TO: CENTERTON PLANNING COMMISSION
 FROM: CENTERTON PLANNING STAFF
 PLANNER: ERIK NYSTROM

PC MEETING DATE: 08/15/2023
 DEV23-03 Laundry List

LAUNDRY LIST: DROP & GO LAUNDROMAT 105 GREENHOUSE ROAD, CENTERTON, AR (1.07 ACRE) LARGE-SCALE DEVELOPMENT

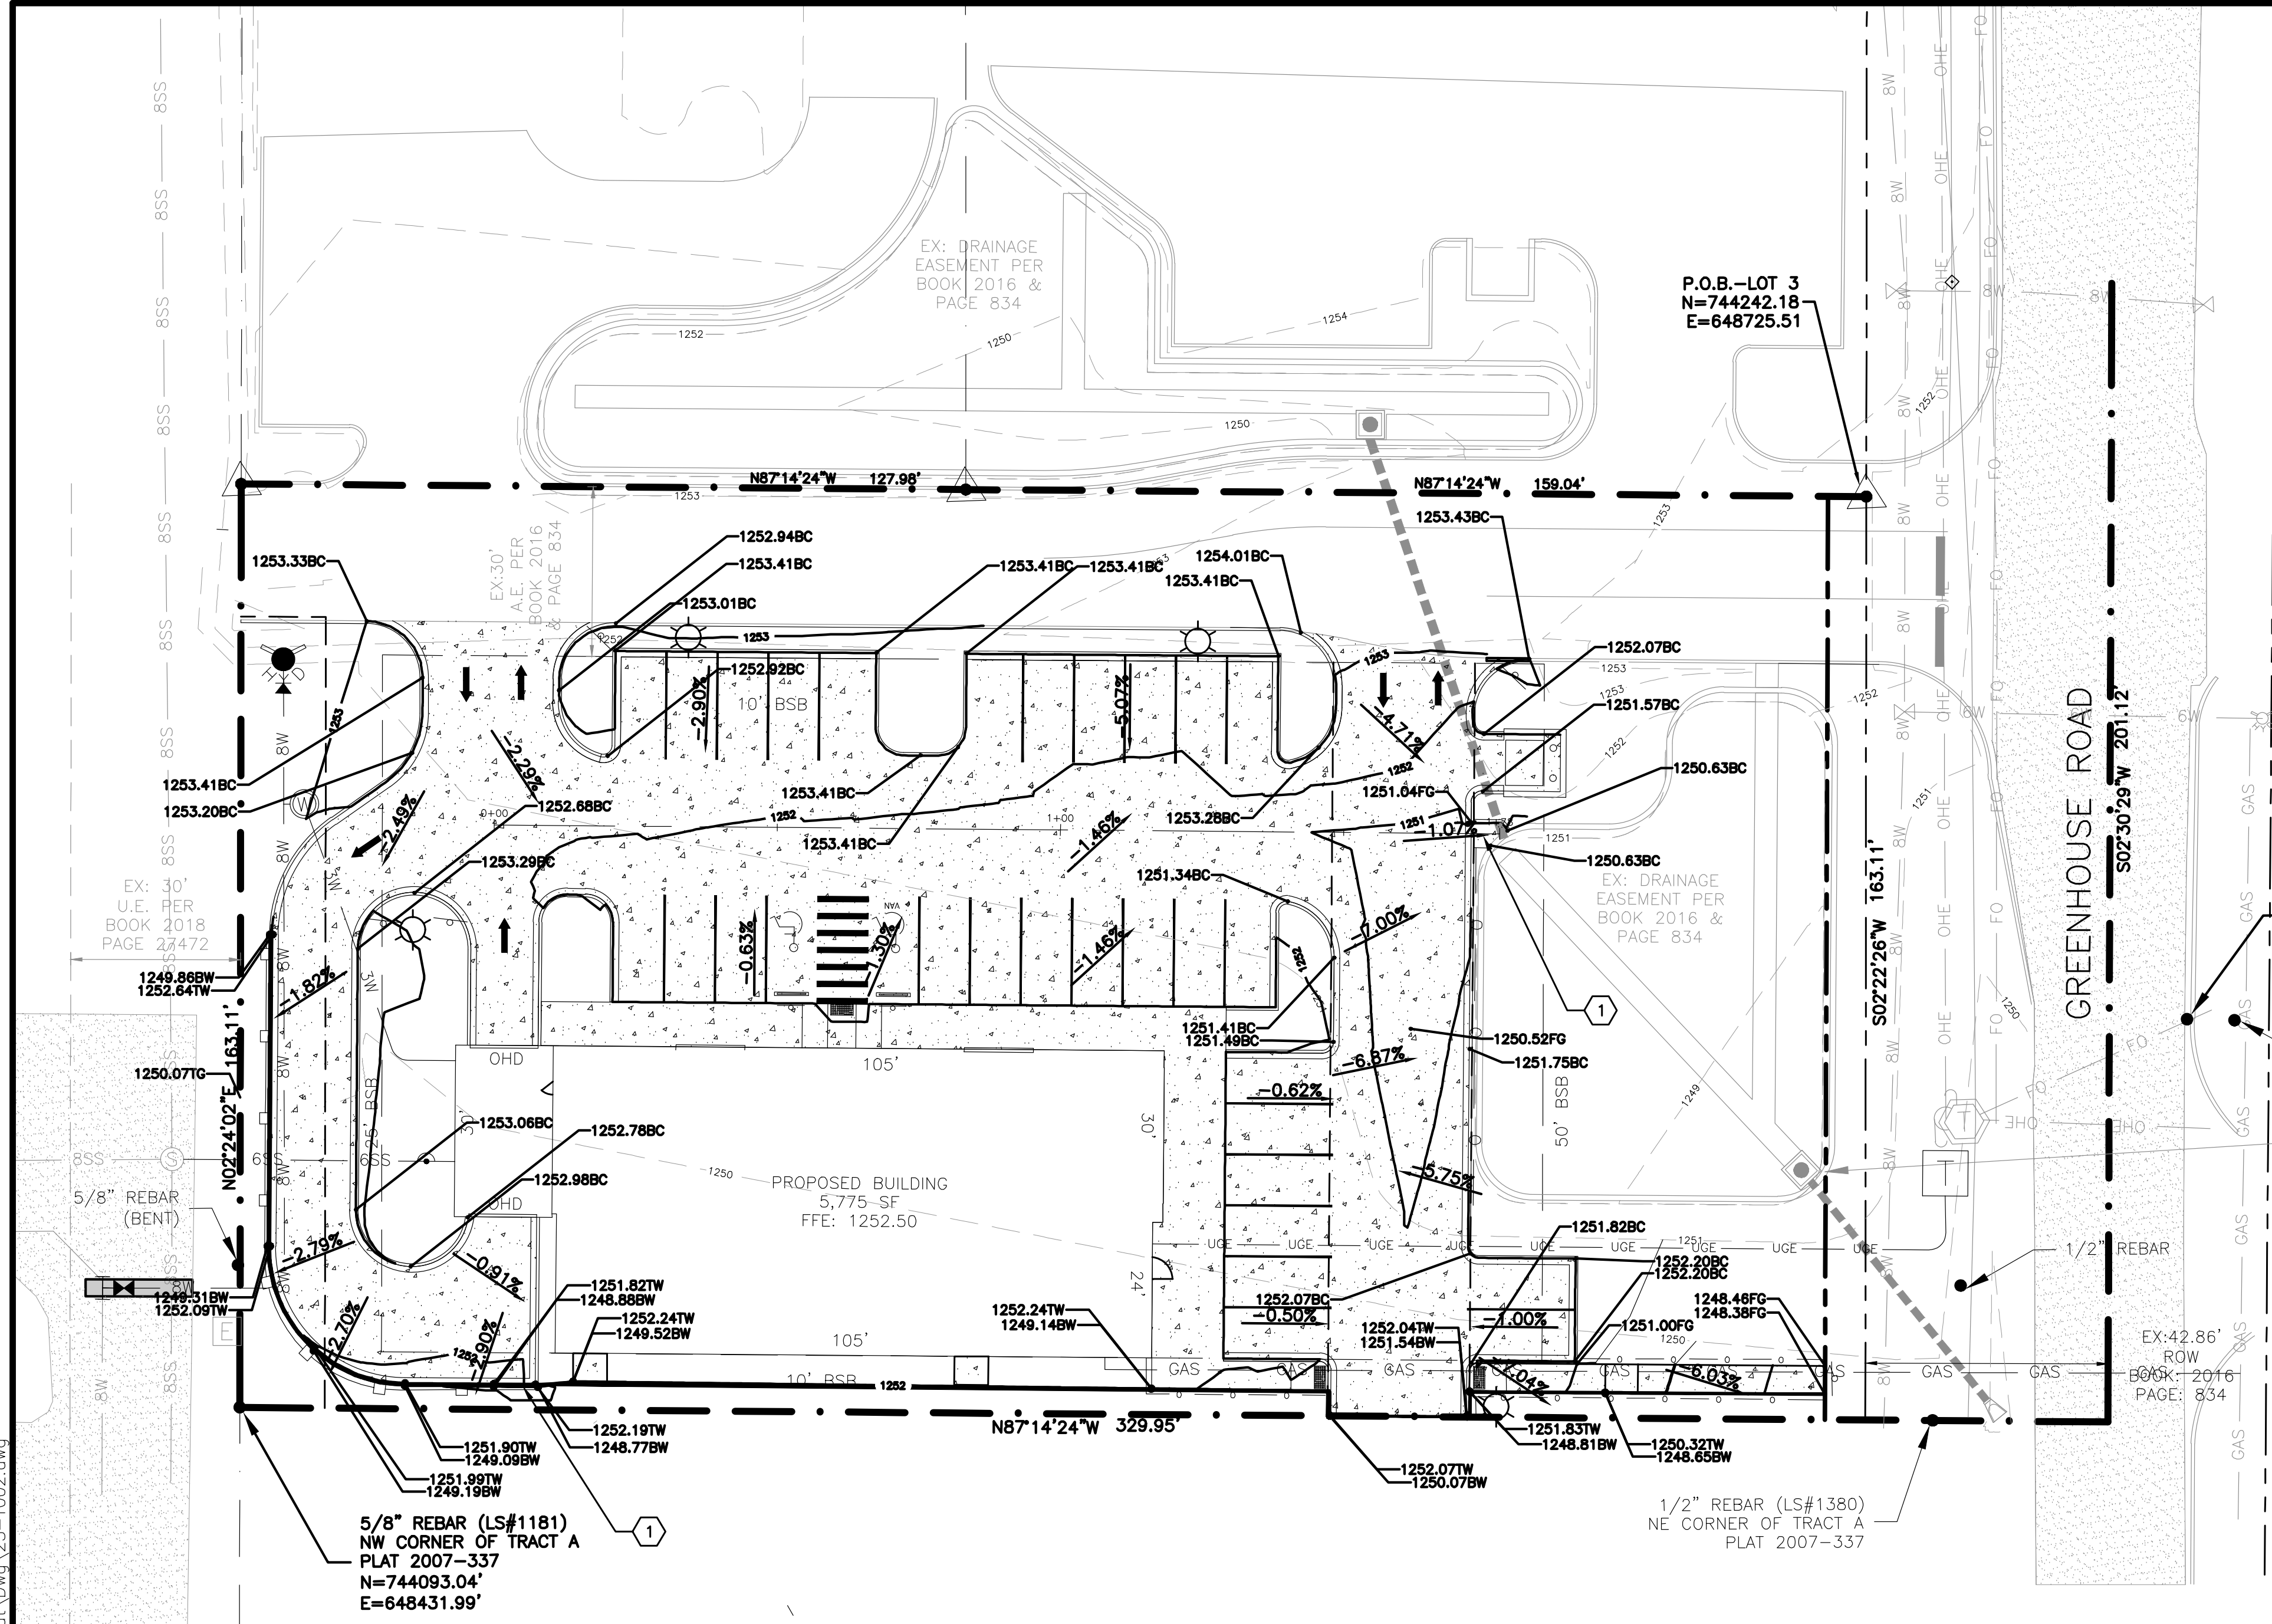
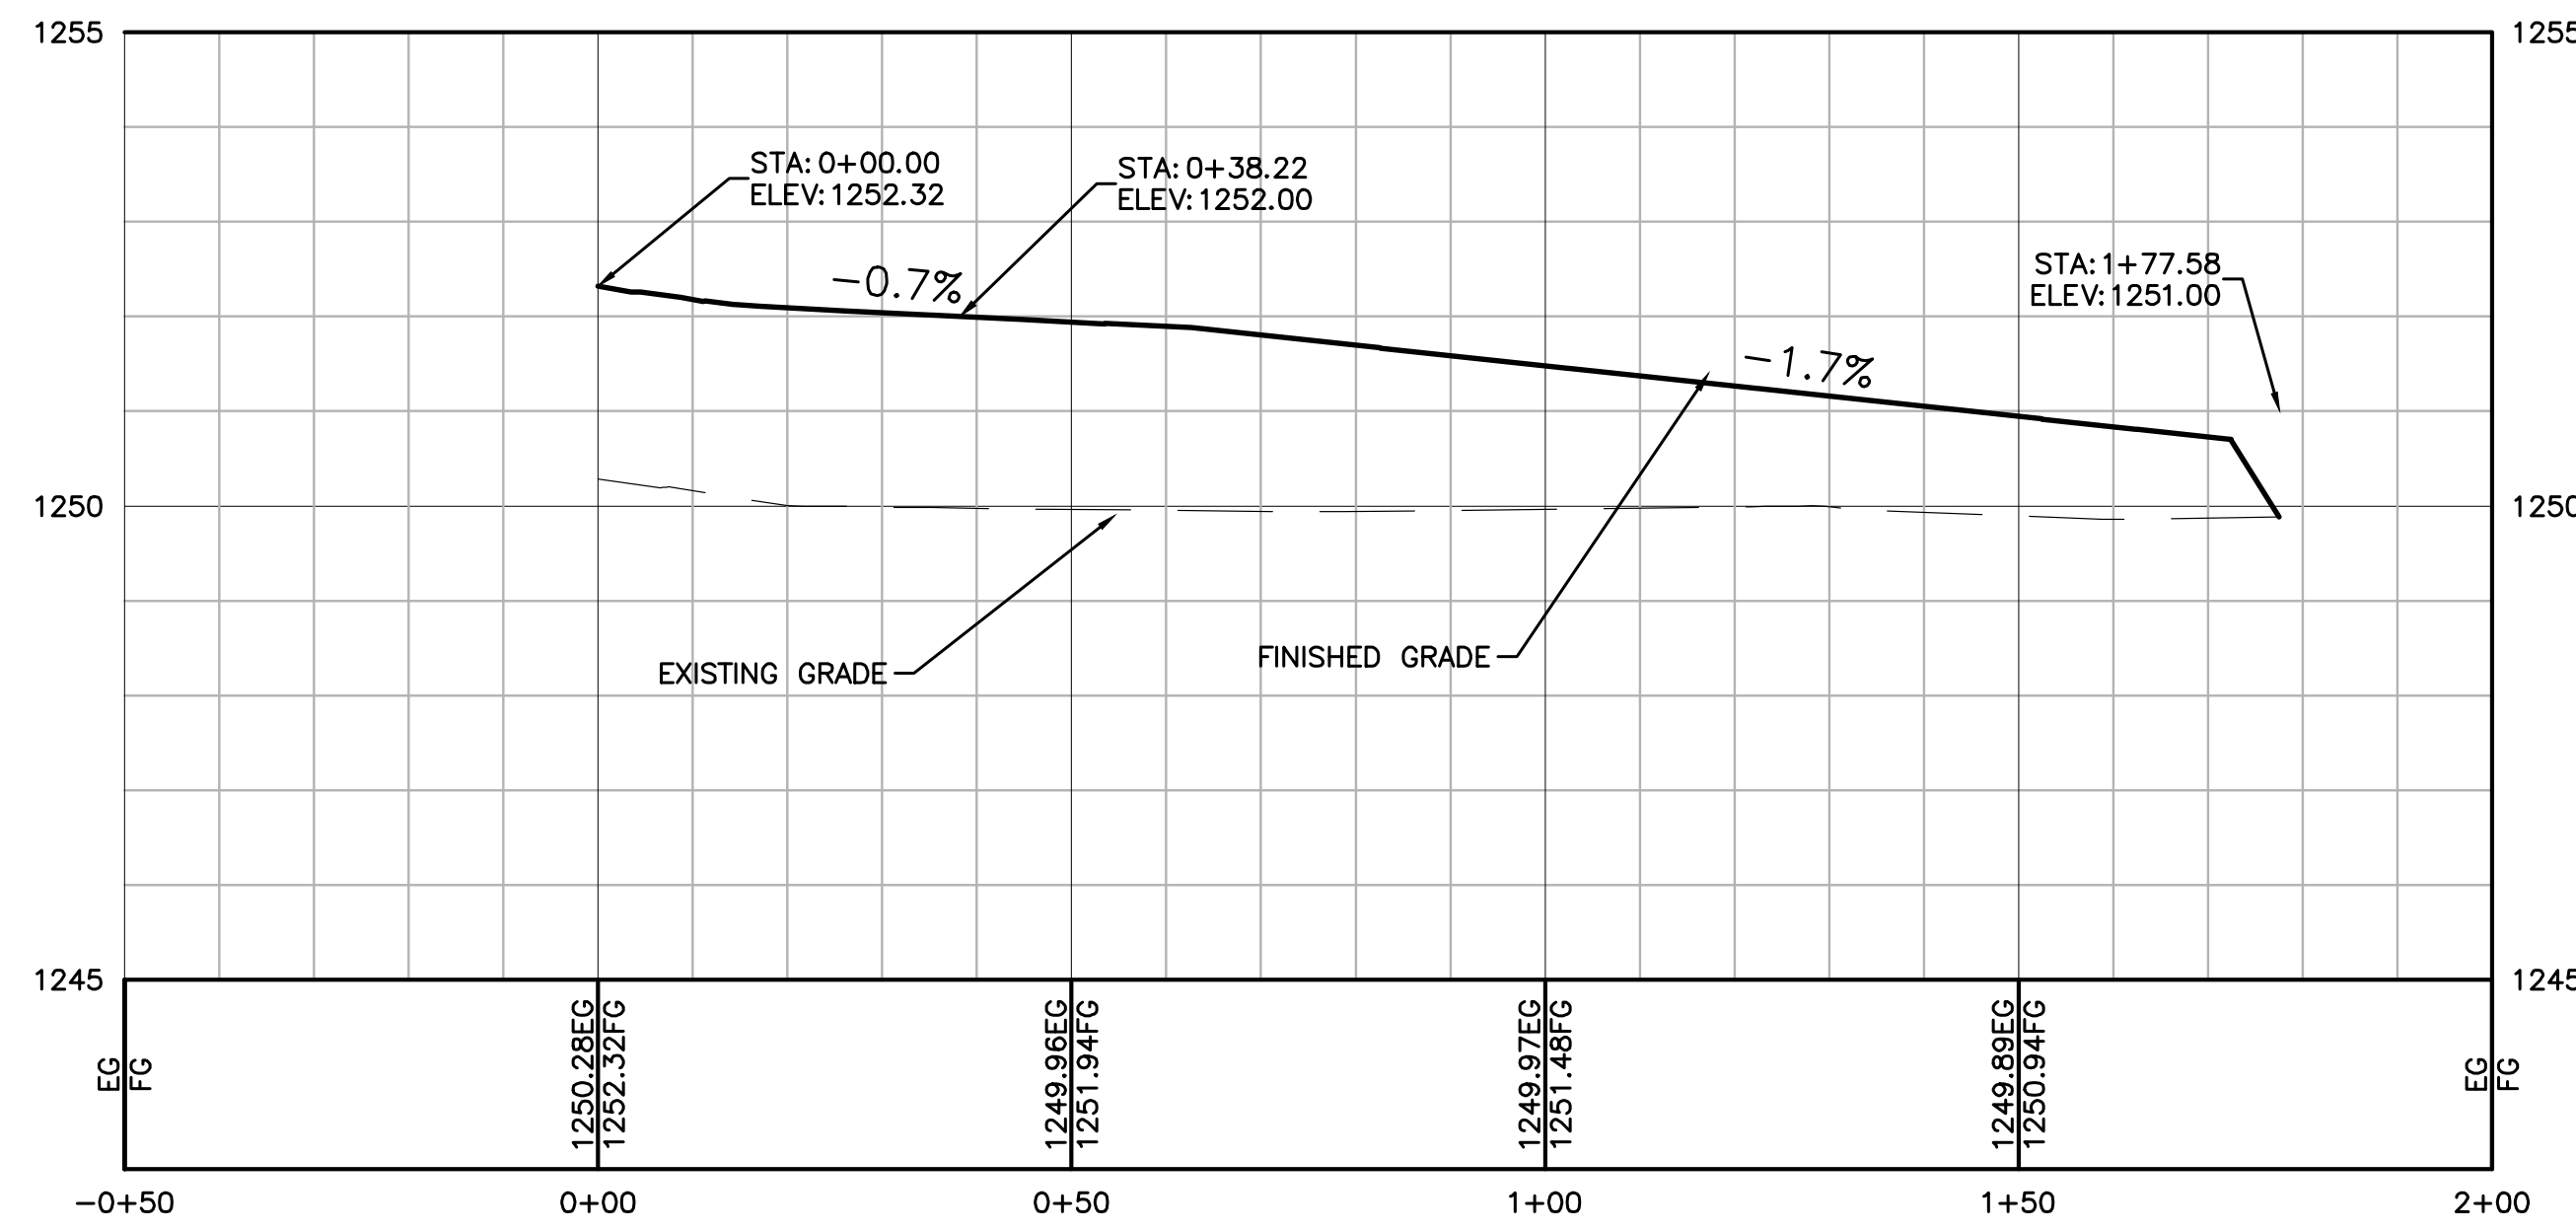
Submittal of a photometric plan is needed for approval as well as clarification on if the detention pond is going to encroach in the proposed Right of way dedication. All other comments have been addressed.

- **The detention pond show the eastern edge encroaching the proposed RoW dedication. Clarification is needed as to who will be responsible for the maintenance of that part.**

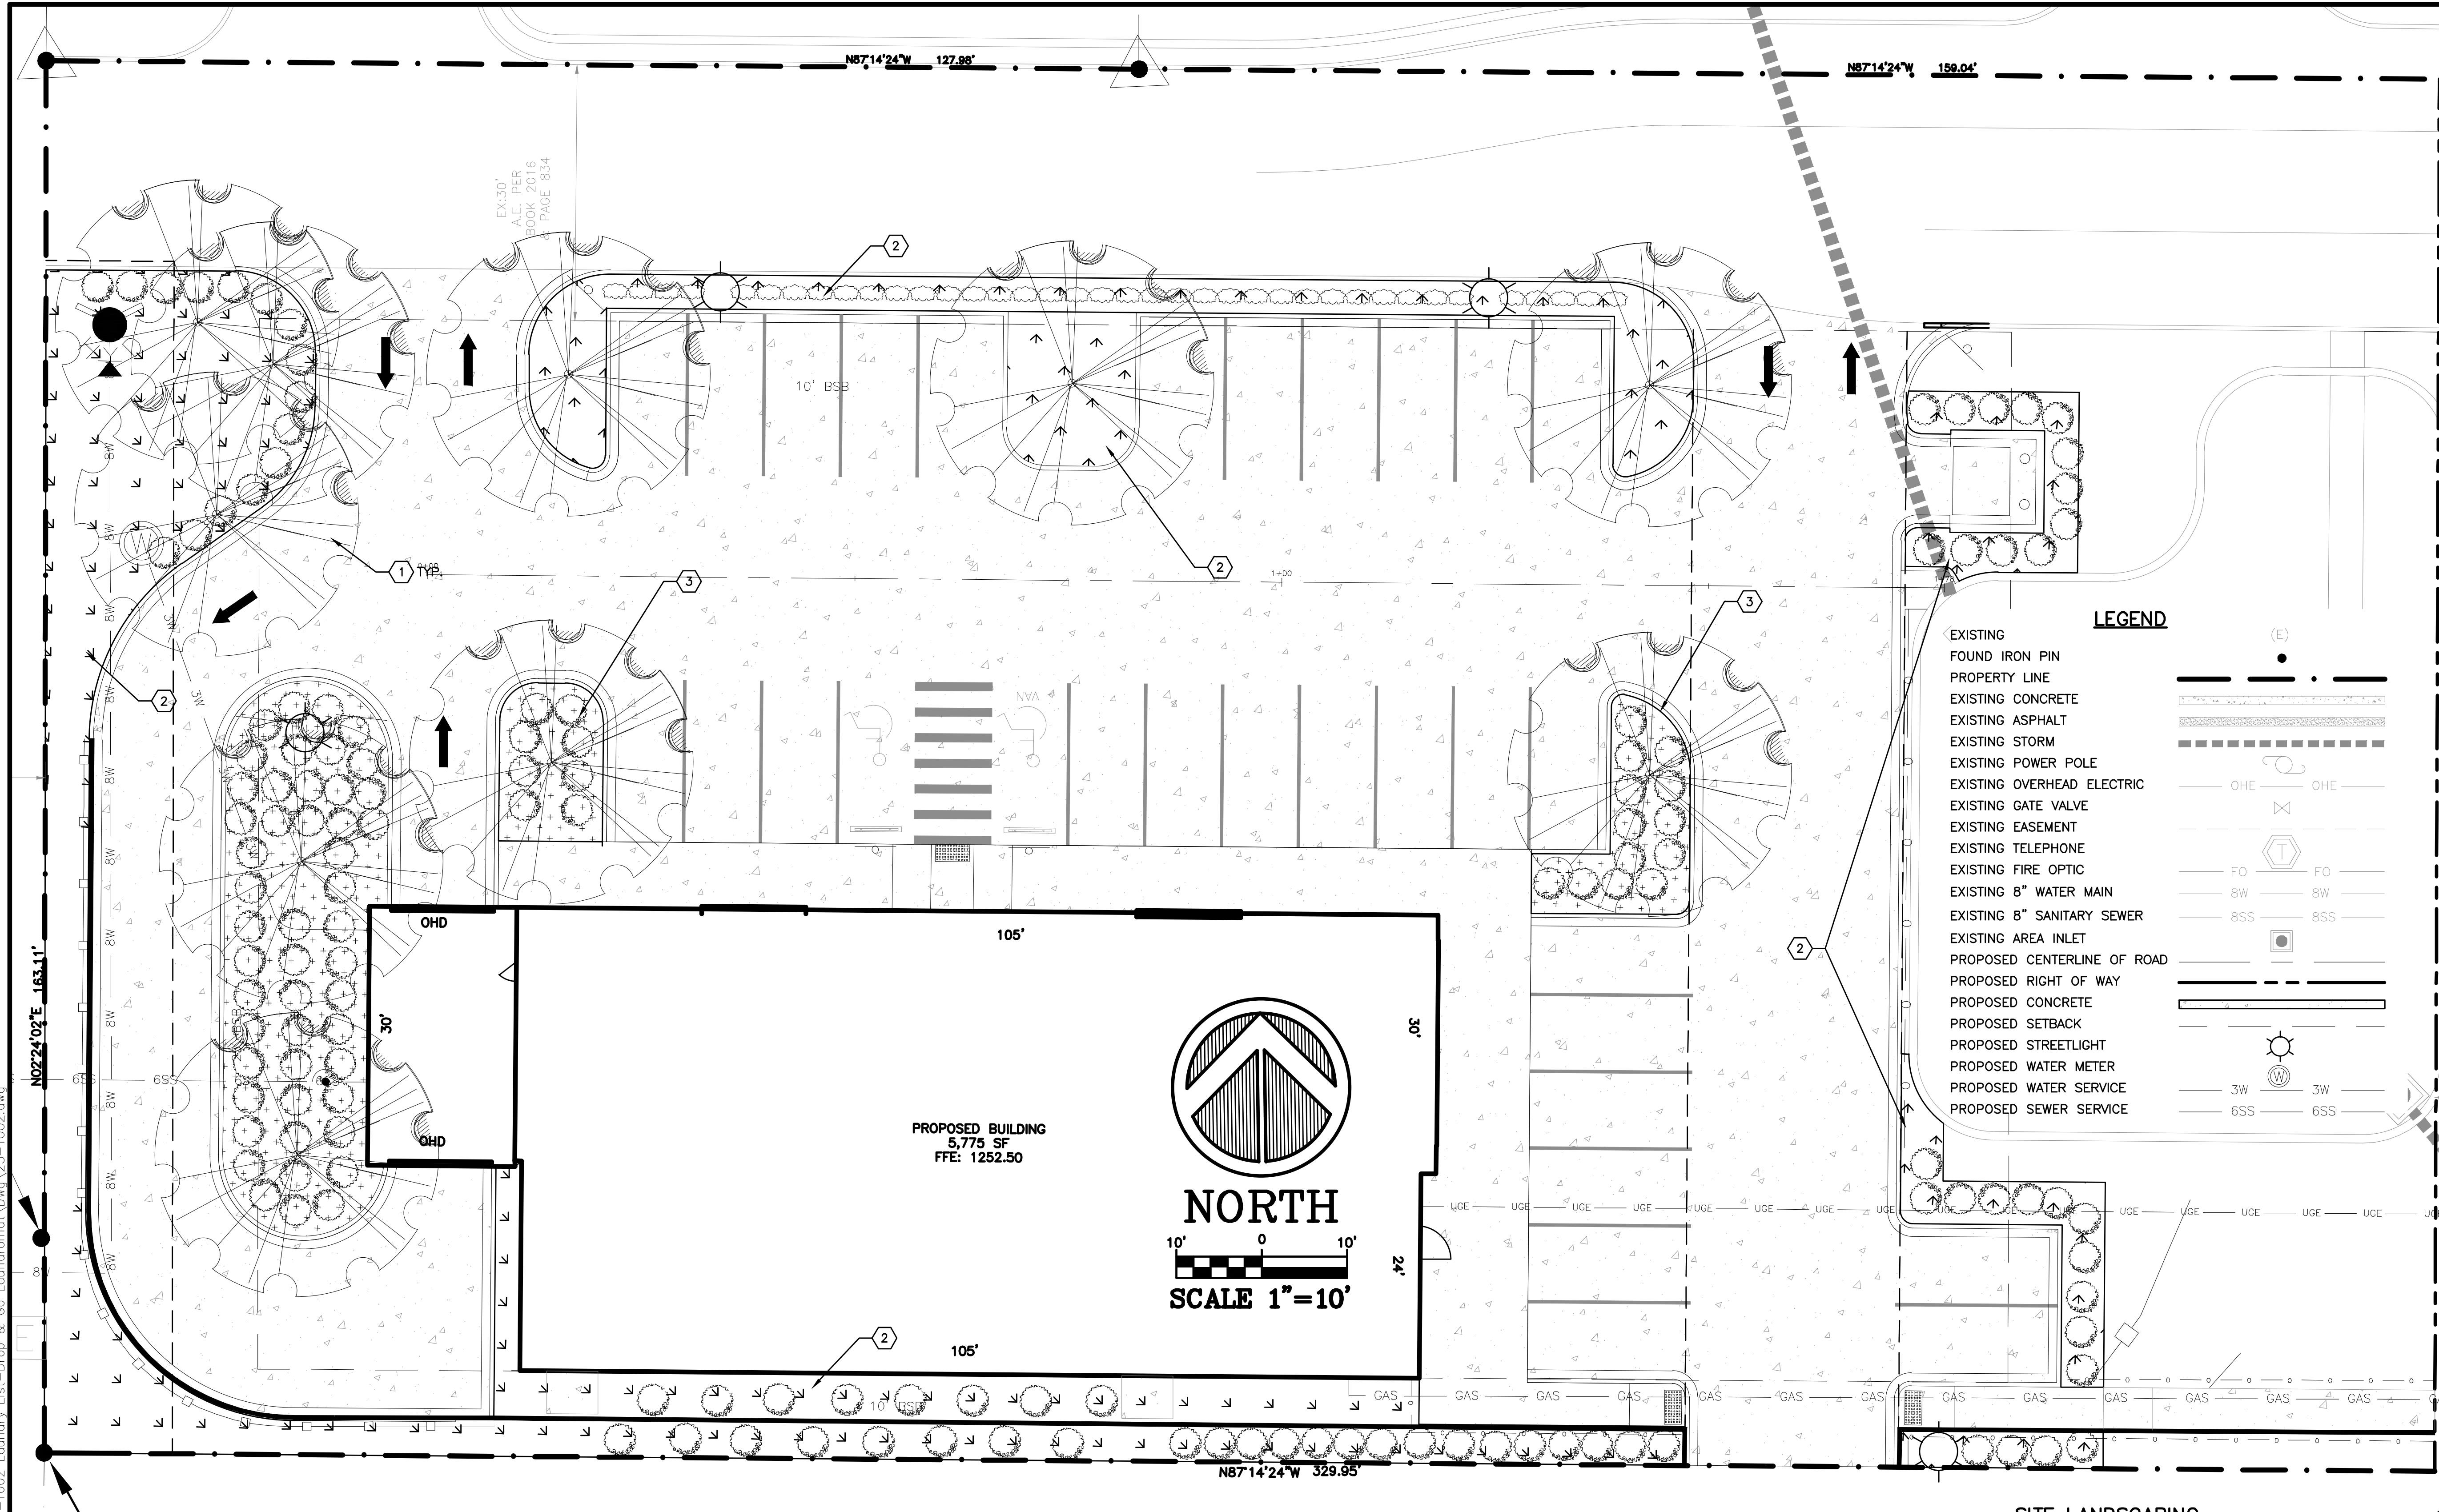
- **STREET TREES:** Due to the expansion of Greenhouse Rd, street trees are proposed to be included in the fee-in-lieu.
- **PARKING LOT LANDSCAPING:** 10 trees and 181 shrubs will be provided. Each parking island will have one or up to three Redbud trees. Euonymus shrubs will be provided on all islands except the 3 north islands, which will contain Boxwood shrubs.
LANDSCAPE SCREENING: No opaque screening is provided. Watercolors Apartments property has landscape screening along their east property line. Euonymus shrubs have been provided around the dumpster enclosure, partially along the south property line, and around the two southeast parking spaces.
- **Staff recommends approval of the landscaping plan.**
